Subject: Class II permissive change Request
FCC ID: N4ZNV1400

Granted on: 09/16/2018

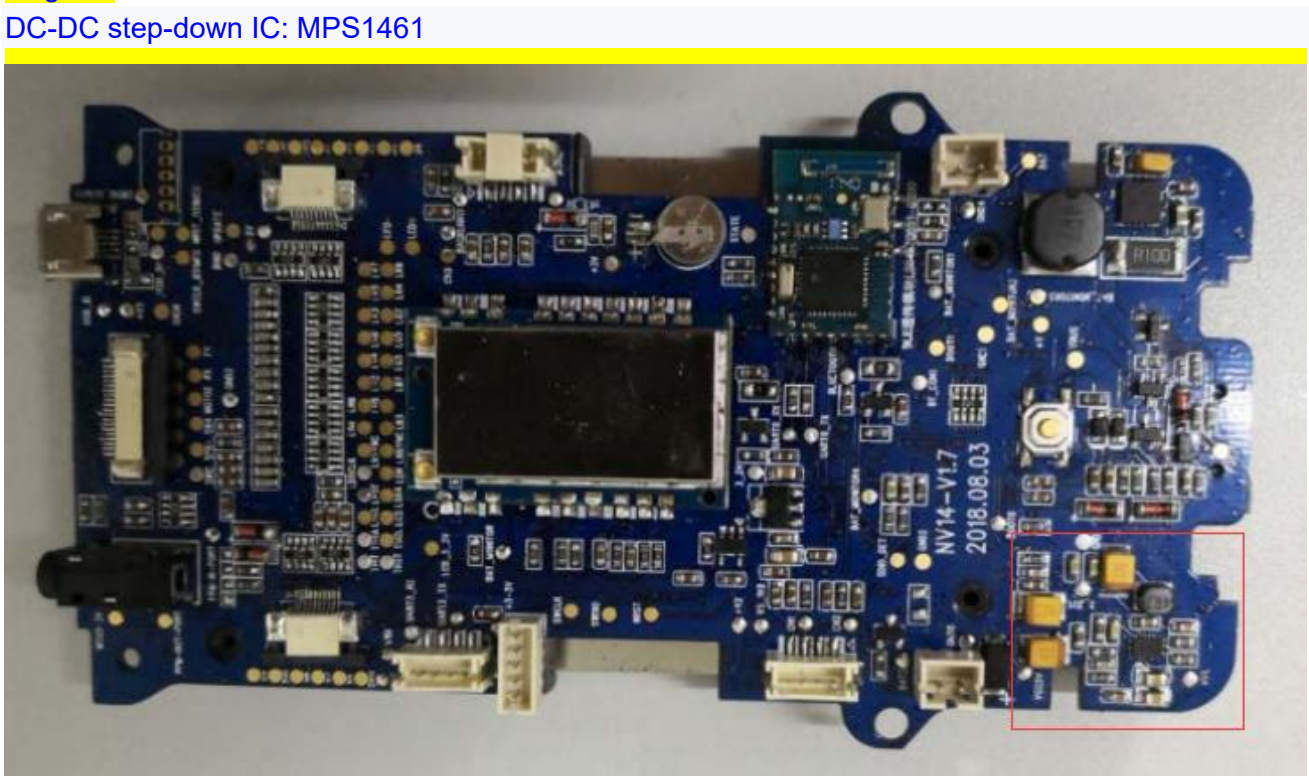
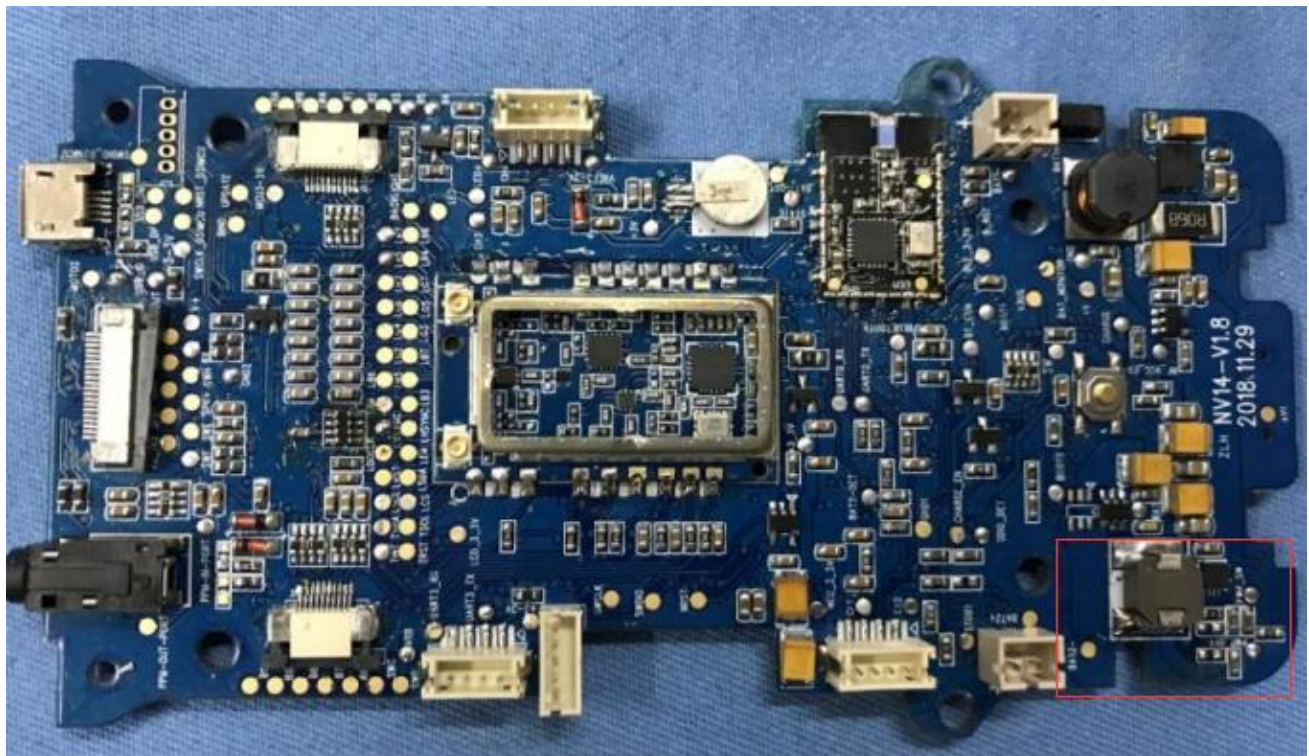
1. Change power supply

Original:

DC-DC step-down IC: MPS1461

New:

DC-DC step-up IC: TPS61235P
